ITEM FOR ENVIRONMENTAL COMMISSION AGENDA

Bull Creek PUD

C814-2009-0139.03 (PUD Amendment)

Planned Unit Development Amendment

Environmental Features

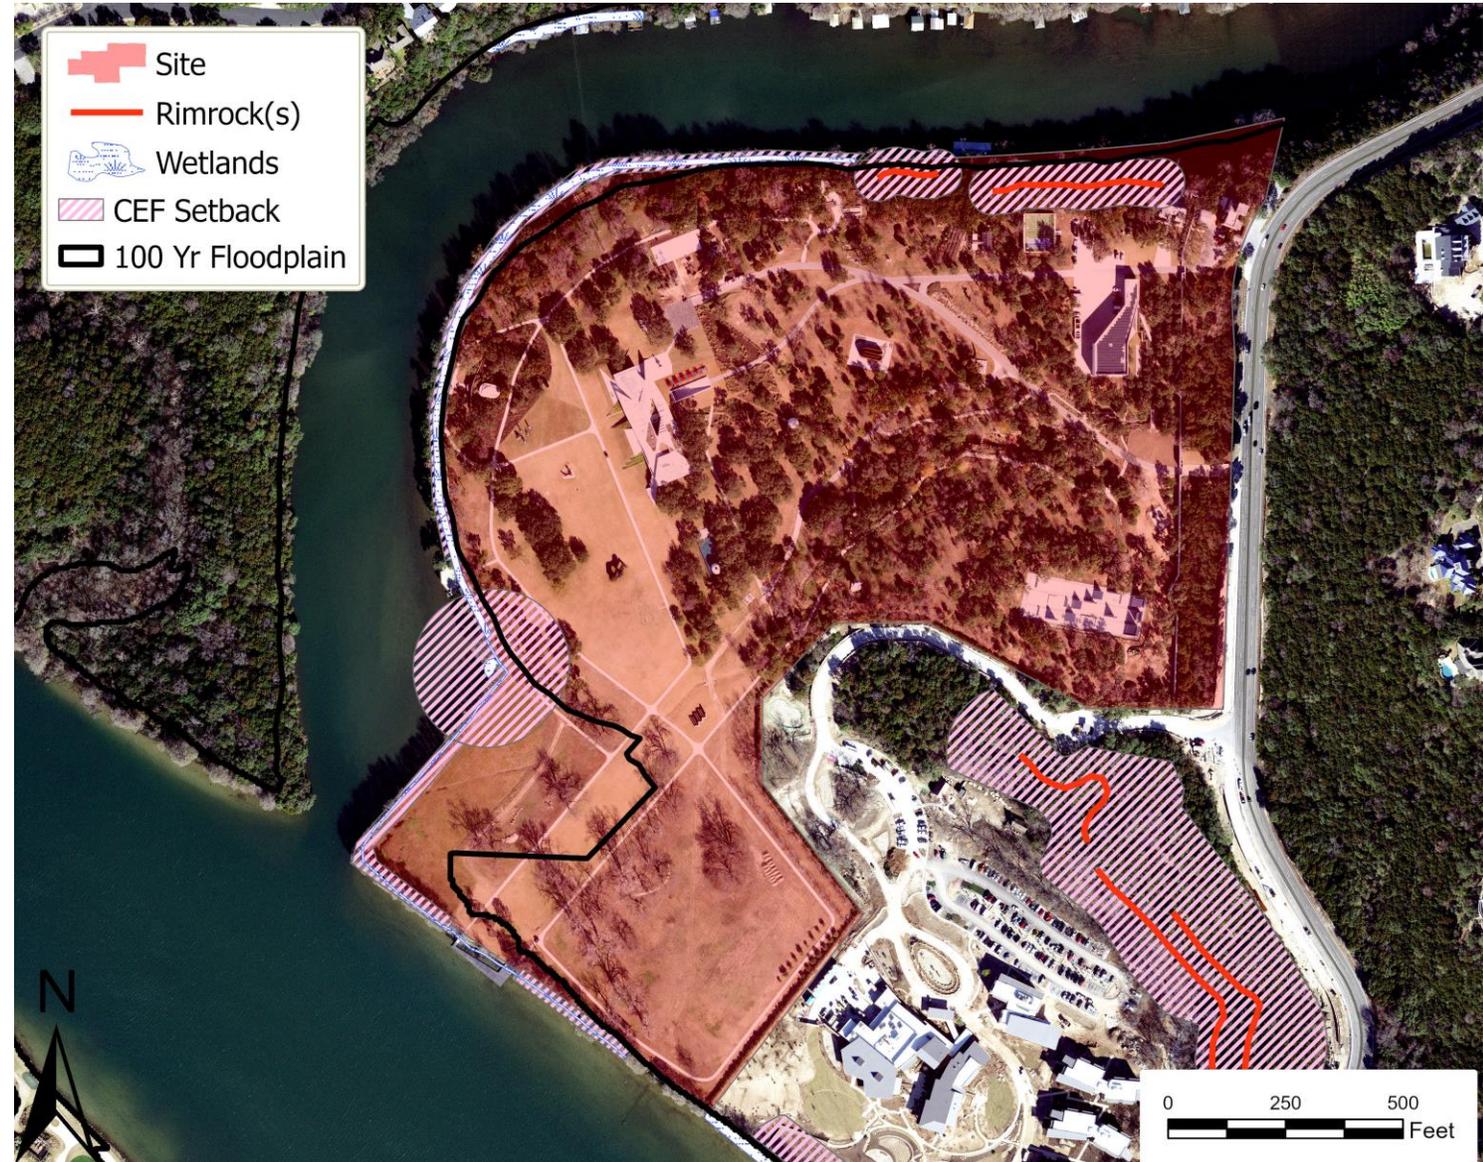
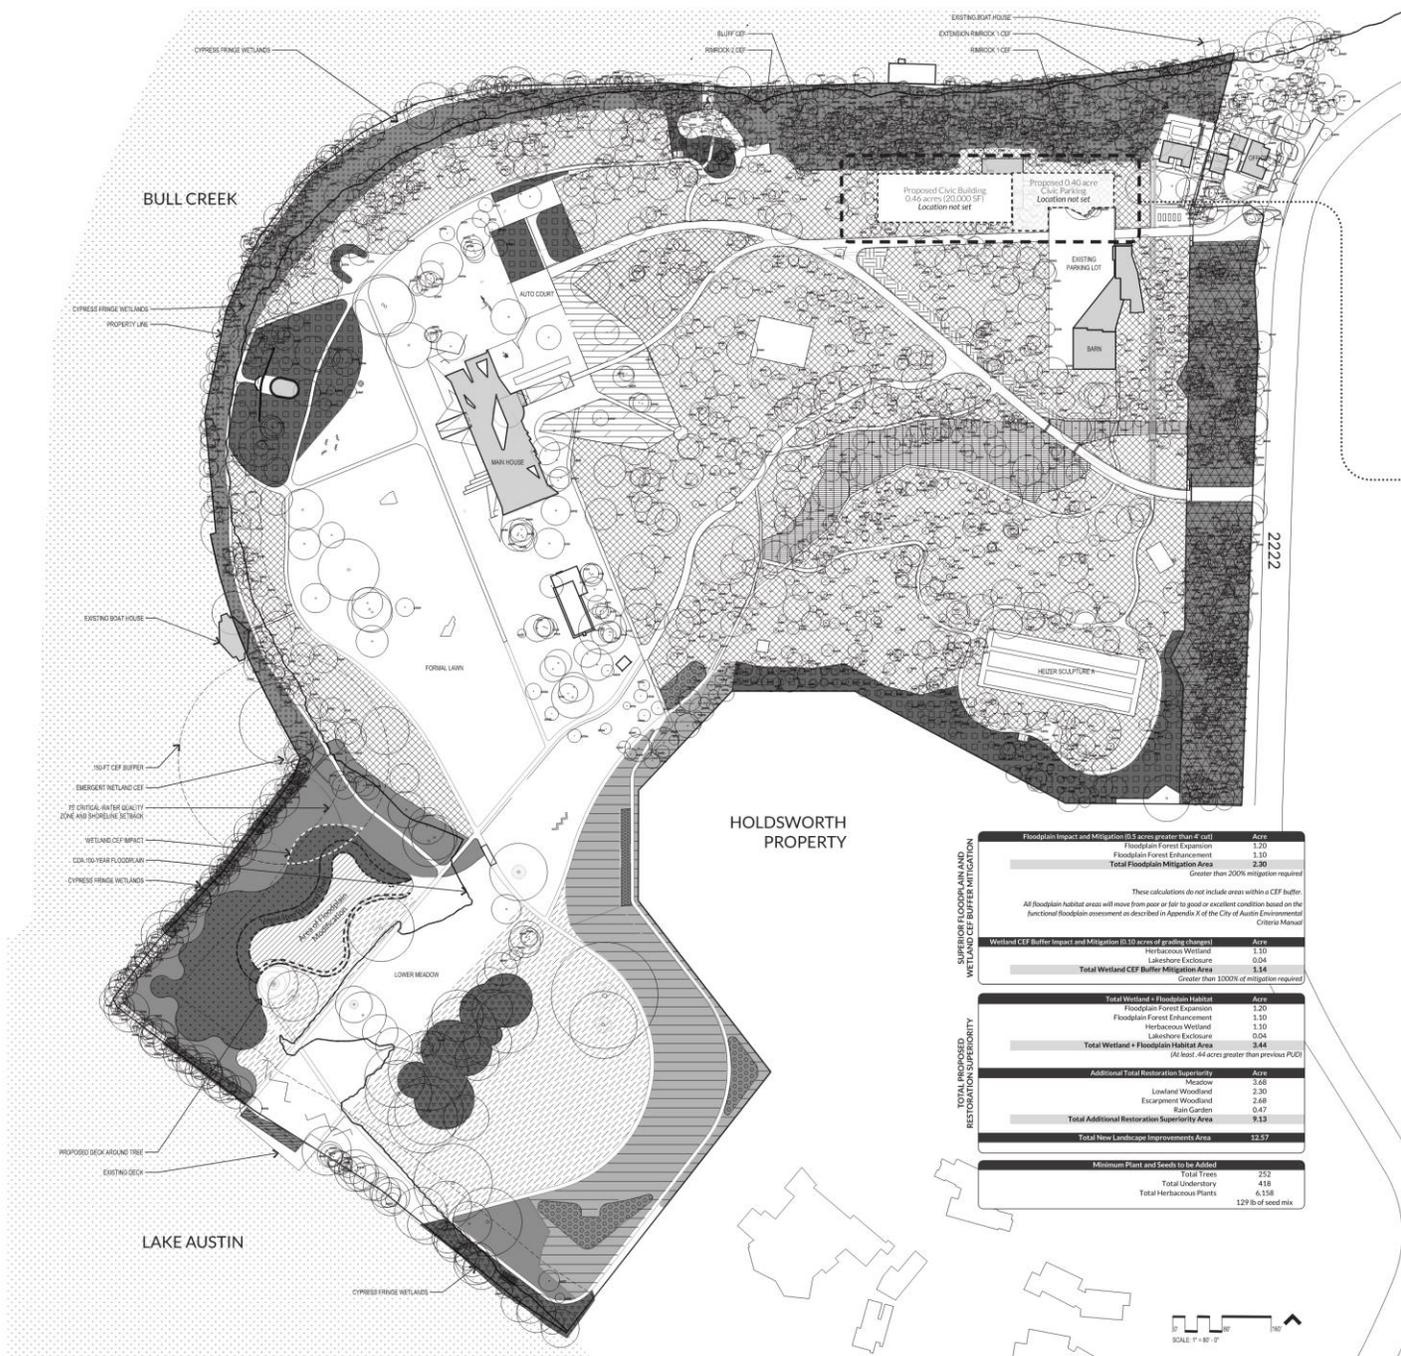
- The property has both rimrock CEFs and wetland CEFs
- The SW portion of the property is in the 100-year floodplain
- The SW bank was impounded before 1958
- The shoreline has a fringe of large cypress trees
- The southern section of the property is dominated by bermuda grass lawn with heritage pecan trees
